Response to Comments Document

Hazardous Waste Listing Determination for Inorganic Chemicals Industry Wastes (Final Rule)

**Volume V:
Responses to Comments ICMP-L0006
through ICMP-L0021**

**Public Comments on the
Inorganic Chemical Manufacturing Listing Determination
(Proposed September 14, 2000)**

Figure 1

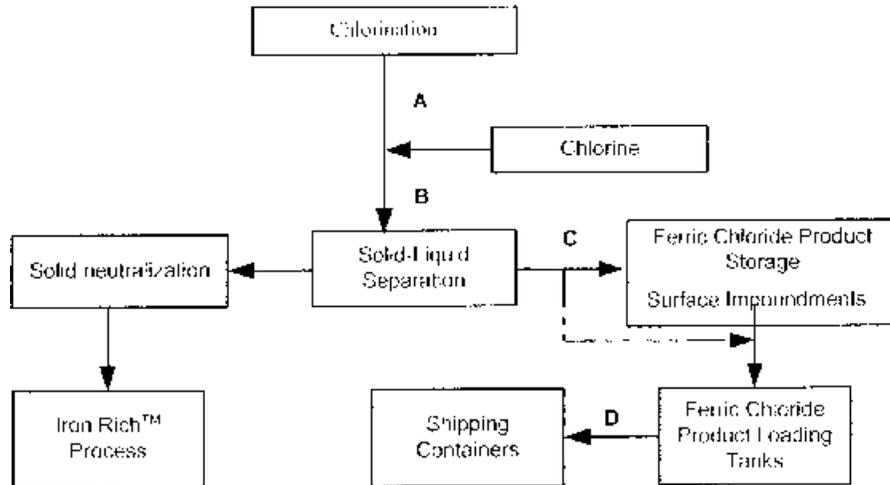
Comment L0017-1: Relocation of Chlorine Addition to the Ferric Chloride Process Stream:

Figure 1 represents how the addition of chlorine was performed prior to 2001 when temporary facilities were installed. In Table 1 the Agency can see that solids are not created by the Chlorine addition.

Response L0017-1: EPA thanks DuPont for the additional information on their plans for the chlorine injection process during the manufacturing of ferric chloride. See our response to comment 22-4a regarding our position on the Bevill status of the ferric chloride residuals. By relocating the chlorine input, DuPont may change its process in such a way that most of their solids will become Bevill exempt. Only solids generated after the addition of chlorine would be captured by the listing.

Figure 2

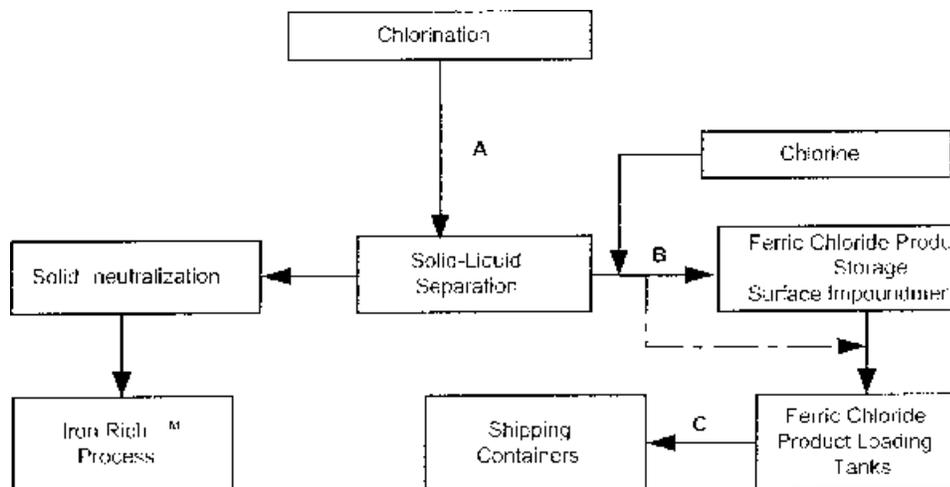
Figure 2 represents how chlorine addition is currently taking place after relocation to a point after solids/liquid separation. Table 2 represents the approximate solids loading in the liquid ferric chloride process stream.

The newly relocated chlorine injection facilities will require additional piping, control valves and environmental equipment to support installation of these facilities 1/2 mile from the current injection point. Permanent facilities are designed and long lead-time equipment is being ordered. The estimated cost of these facilities is \$1,125,000. The expectation is to complete the permanent installation by October of 2001.

Figure 3

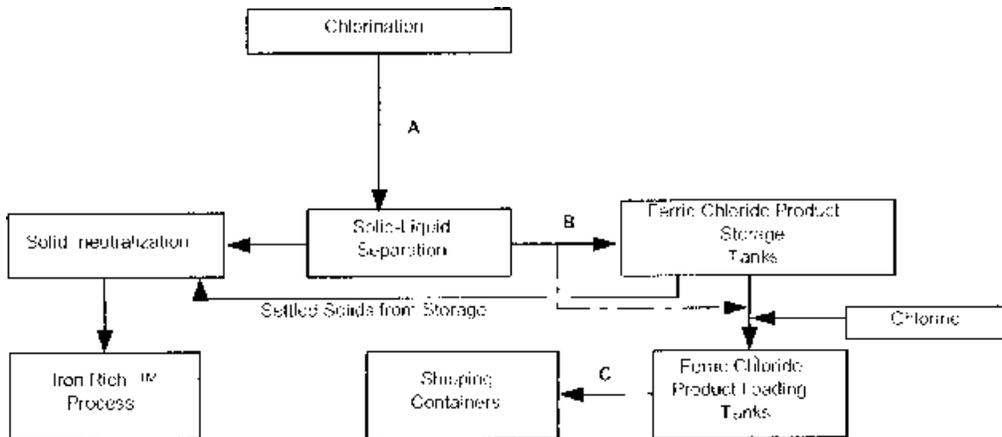
Figure 3 represents the planned changes to move chlorine addition and the installation of the new tanks. It is estimated that about 50 tons of ferric chloride solids will settle out in the new storage tanks per year. These solids will either be pumped back to the neutralization and stabilization facilities, or evaluated for disposal upon removal from the product storage tank. DuPont would like the option to evaluate the suitability of tank solids for potential conversion to iron-products absent the impact of listed waste code K178.

Inclusion of ferric chloride tank solids in the K178 listing would impart a confusing and complex RCRA mixture and derived-from element into a process RCRA waste management scenario historically regulated under multiple RCRA waste characteristics. For example, if the Agency proceeds with a K178 listing for ferric chloride solids, then the RCRA waste classification would not be just K178, moreover it could be EPA codes K178, D002, D007, D008 (depending upon which characteristics apply). The reason is that the proposed LDR treatment standards at 65 FR 55780 do not address the characteristic of corrosivity, chromium or lead toxicity. Thus, a generator is required to include ALL RCRA hazardous waste characteristics in addition to the listing code where the listed waste does not specifically address the constituents that give rise to the additional characteristics (see Technical Corrections to Phase 3 LDRs, I/31/91). Subjecting ferric chloride solids to the K178 listing preserves some of the worst aspects of the RCRA mixture and derived-from rule and, considering the type of facility changes completed or planned and applicable ferric chloride solids waste characteristics, the listing may not be necessary in order to achieve the

Response L0017-2: EPA thanks DuPont for the additional information. See our response to comment 22-10e regarding the closure of the surface impoundments. If DuPont has not closed the surface impoundment prior to the effective date of the listing, it will need to retrofit. The ferric chloride listing is a “non-HSWA” rule, so it will take effect—for the Edge Moor plant—after Delaware adopts it. With regard to the mixture and derived-from rule comment, EPA disagrees with the commenter that the regulations place significant additional burden on the facility. According to the comment, prior to the effective date of the K178 listing, the tank bottoms would be classified as D002, D007, and D008 (corrosivity and toxicity for chromium and lead, respectively). Treatment standards for nonwastewater forms of those characteristics requires treatment of the primary constituent and any underlying hazardous constituents. The treatment standards for K178 are merely a subset of the list of underlying hazardous constituents. Moreover, the values of the treatment standards themselves are equivalent. Once listed, these constituents would still require treatment if their concentration was above the universal treatment standard levels. Therefore, the addition of K178 should not require any additional treatment than what was required of tank bottoms prior to the listing. The only additional burden is that imposition of the listing will require the treated tank bottoms to be disposed in a Subtitle C (hazardous waste) disposal unit rather than a Subtitle D (nonhazardous waste) land disposal unit. Prior to the
